Bidding Addendum

Addendum No. 2

Issue Date:	October 20, 2026	**CPL Project No:**	R25.19314.00
Client:	Lakeland Community College	**Client Project No:**	TK26SEP30
Project:	“Breakers” Food Service Renovation		
From:	CPL Architects, Engineers, Landscape Architect D.P.C. 25 Main Street, Suite 200 Westlake, Ohio 44145	**Contact:**	Kiernan Weese kweese@cplteam.com
Distribution To:	All Pre-Bid Attendees Lakeland Community College Tec Inc. TriMark USA	**Contact:**	N/A

Issued: 9/28/2026
Scale: As indicated
Project Status: BID AND PERMIT
Drawn By: CPL
Checked By: CPL
Drawing Title: LEVEL 1 FLOOR PLAN - OVERALL
Drawing Number: A201

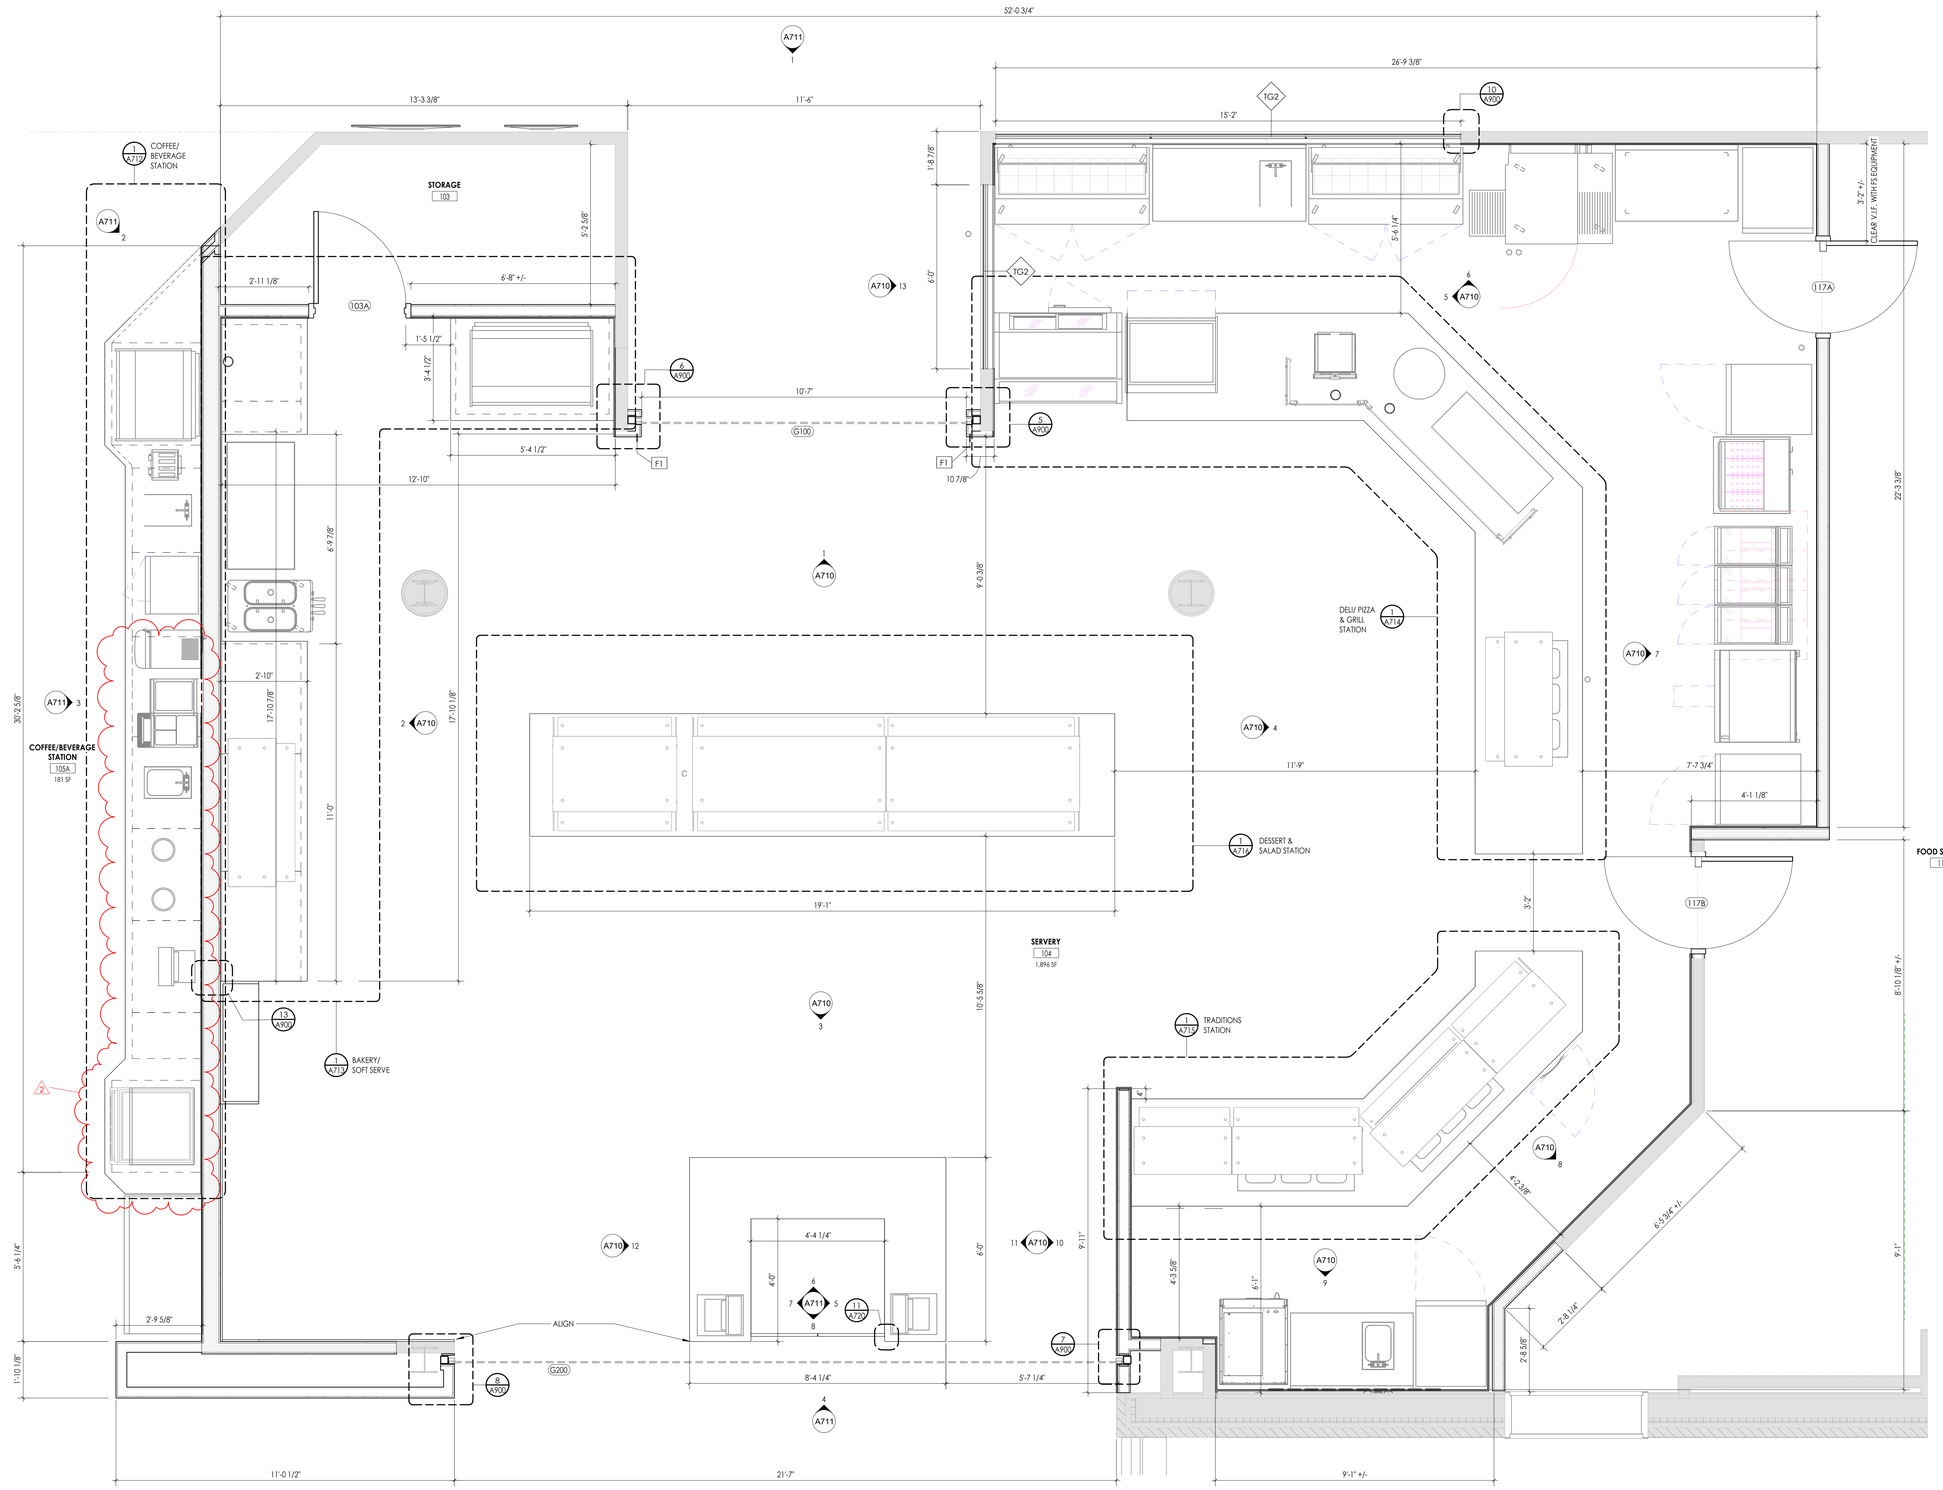
A201	Level 1 Floor Plan - Overall
	Revised Coffee/Beverage Station layout
A701	Level 1 Enlarged Servery Plan
	Revised Coffee/Beverage Station layout
A711	Elevations
	Revised elevation 3/A711 for Coffee/Beverage Station layout
A712	Servery Callouts and Details
	Revised details 1/A712 and 5/A712 for new FS equipment
A900	Door Panels, Frame Types & Schedules
	Revised panel type and hardware set for Door 103A
E001	Electrical Symbols, Notes, & Details
	Revised Communications Riser Diagram
E101	Level 1 Electrical Demolition Plan
	Added clarification for Alternate #3 scope. Added keynote to relocate receptacles
E102	Level 2 Electrical Demolition Plan
	Added clarification for Alternate #5 scope.
E202	Level 2 Power Plan
	Added keynote for new core drill and firestopping for new data cabling
E301	Level 1 Lighting Plan
	Added clarification for Alternate #3 scope. Added exit sign locations. Revised Fixture Type C locations

Drawing Number
E302

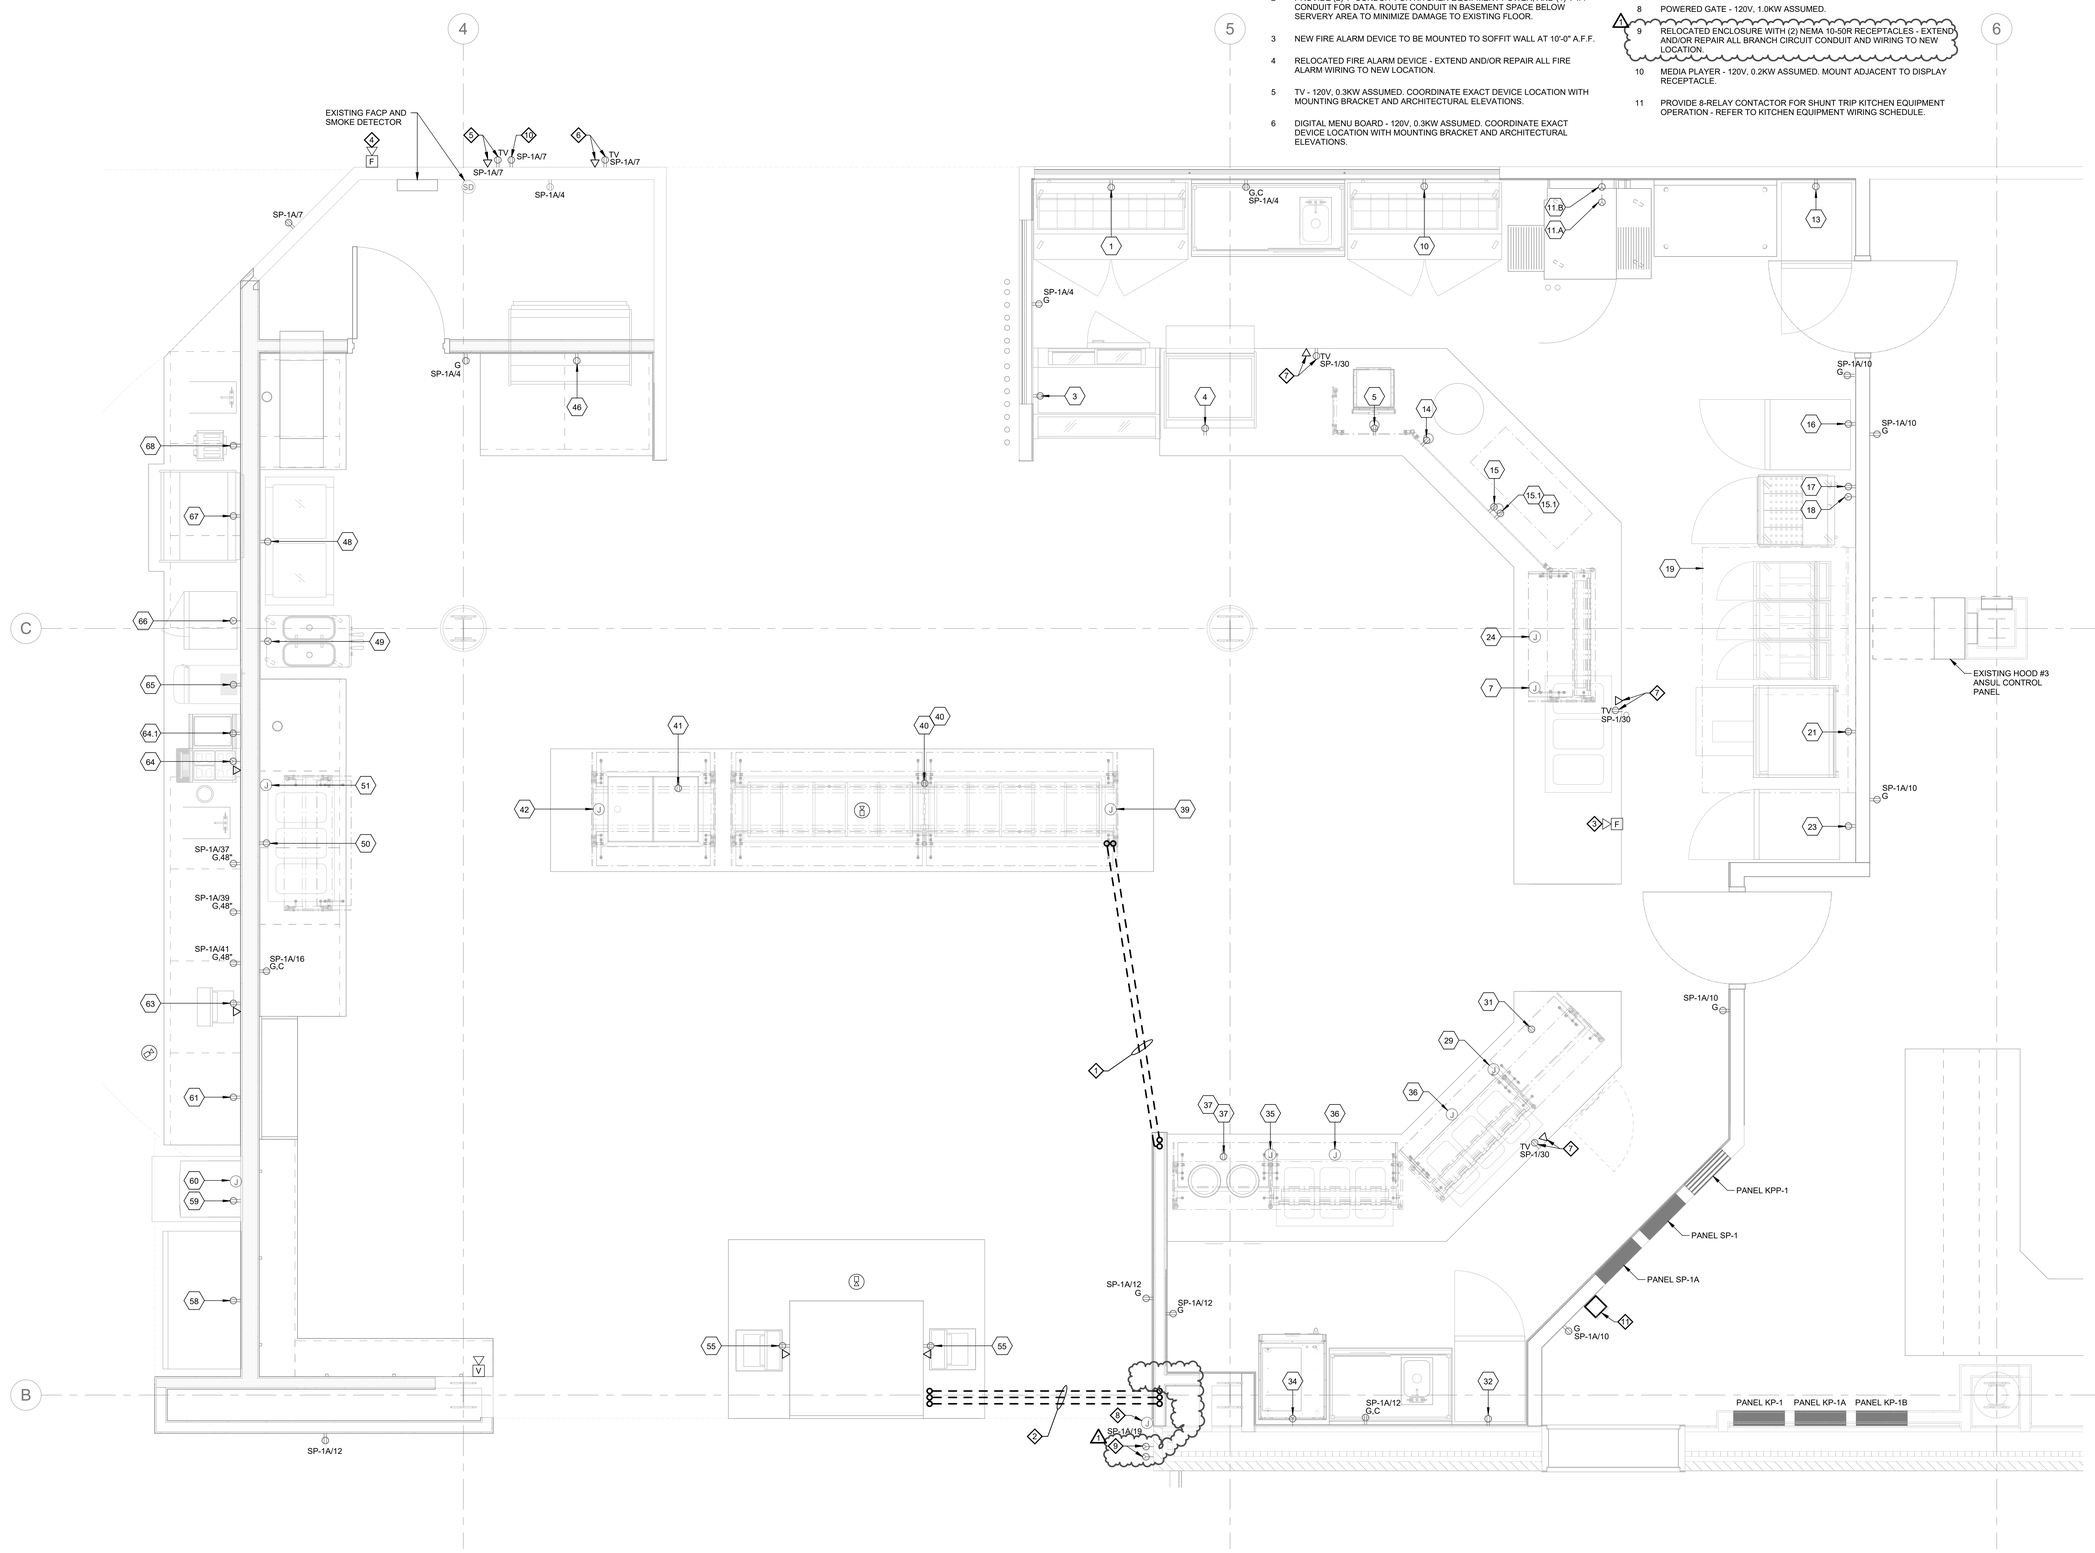
E302	Level 2 Lighting Plan
	Added clarification for Alternate #5 scope.
E701	Enlarged Servery Power Plan
	Added keynote to relocate receptacles
E900	Electrical Schedules
	Added Fixture Type X
P001	Plumbing Schedules, Details, Symbols, & Notes
	Revised Sanitary Isometric Diagram
P201	Level 1 Waste Plumbing Plan
	Revised waste plumbing
QF101	Foodservice Equipment Plan and Schedule
	Revised equipment #59 and #60. Added equipment #70. Shifted location of #62.1 and #63.

WATER FILTER DETAIL

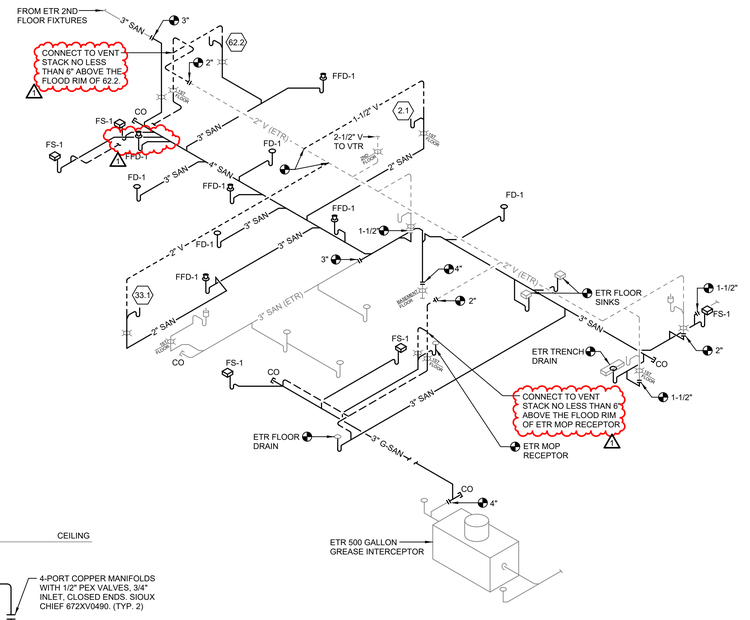
RFI 12.7 QF201/QF202 remarks vs P001 WF-1 detail - Foodservice schedule says "source FW from central filtration system in building." Plumbing shows a new local WF-1 Everpure filter and PEX

RFI 12.18 P001 WF-1 - WF-1 specified as Everpure EV9328-06 "or equal." Confirm the model and cartridge configuration are final, and whether spare cartridges or a start-up cartridge change are required.

Answer *There is no central filtration system currently. Refer to P drawings for new water filtration work. Existing point-of-use filters should be discarded where they are being replaced by the central filter.*

Answer *I will only allow a substitution that meets or exceeds every item in the Plumbing Equipment Schedule. It is only required to provide the 1 set of cartridges that shall be installed.*

COFFEE/BEVERAGE AREA 3D VIEW
Not to Scale

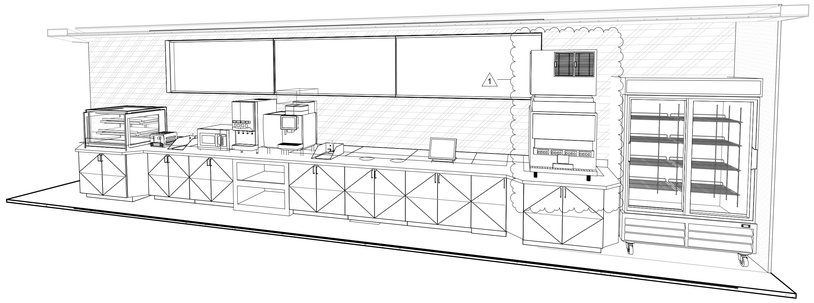
QF201	Foodservice Plumbing In-Slab Rough-In Plan and Schedule
	Revised equipment #59 and #60. Shifted location of #62.1 and #64.
QF202	Foodservice Plumbing Above Slab Rough-In Plan and Schedule
	Revised equipment #59 and #60. Shifted location of #59 #,60, #61 and #62.1.
QF301	Foodservice Electrical Rough-In Plan and Schedule
	Revised equipment #59, #60, and #70. Shifted location of #59, #60, #61, #63.
QF401	Foodservice Special Conditions Plan
	Added Beverage System Notes to equipment #59
QF502	Foodservice Elevations
	Removed detail tags from elevations
QF503	Foodservice Elevations
	Revised Detail 5 equipment
QF504	Foodservice 3D Views/Elevations
	Revised Coffee/Beverage Area 3D View
